STRUCTURAL ENGINEERS REPORT

Pex Hill
Cronton
WA8 5QW

9137-ADS-XX-XX-RP-S-001

12th April 2024

2024 PHOTOS

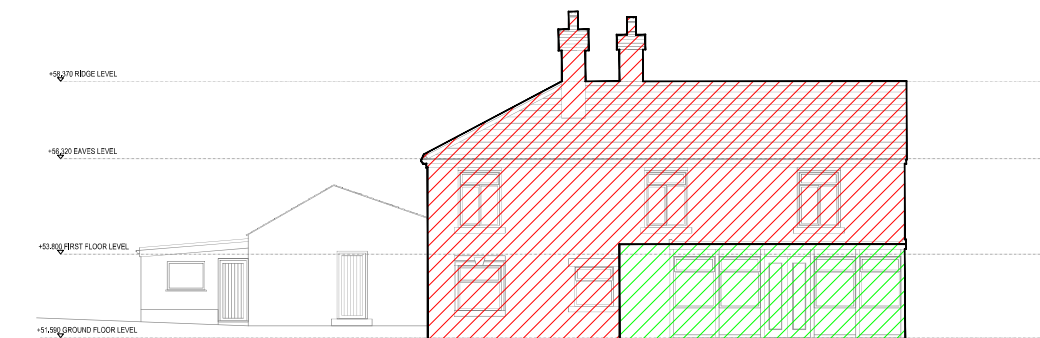
It is clear that the structural stability of the building has decreased since our first inspection and could be considered to be progressively worsening with some parts of the remaining building potentially now considered to fall under the classification of dangerous structures. We have marked up plans and elevations to illustrate the areas already perished and areas which would need to be taken down and rebuilt. Approx. 80% of the wall panels have either collapsed already or would require rebuilding, in addition to the entire roof and first floor structures. As such we see little benefit in attempting to dismantle/refurbish 20% of the remaining existing walls and would recommend that it is demolished and rebuilt following a successful planning application.

ELEVATION B-B

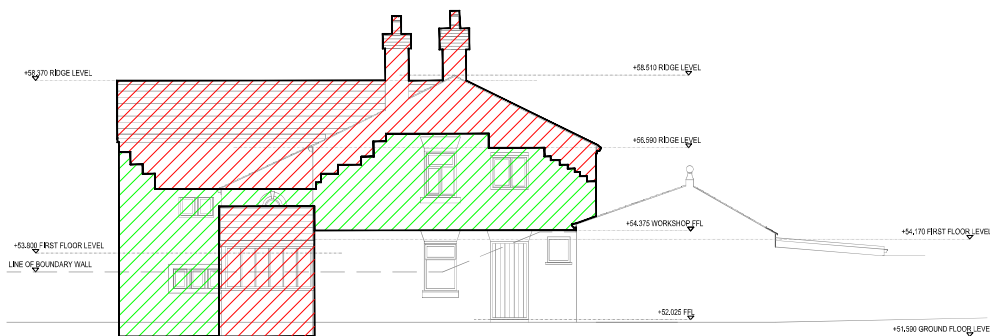
- COLLAPSED
- AREA OF STONE WALL TO BE TAKEN DOWN AND REBUILT
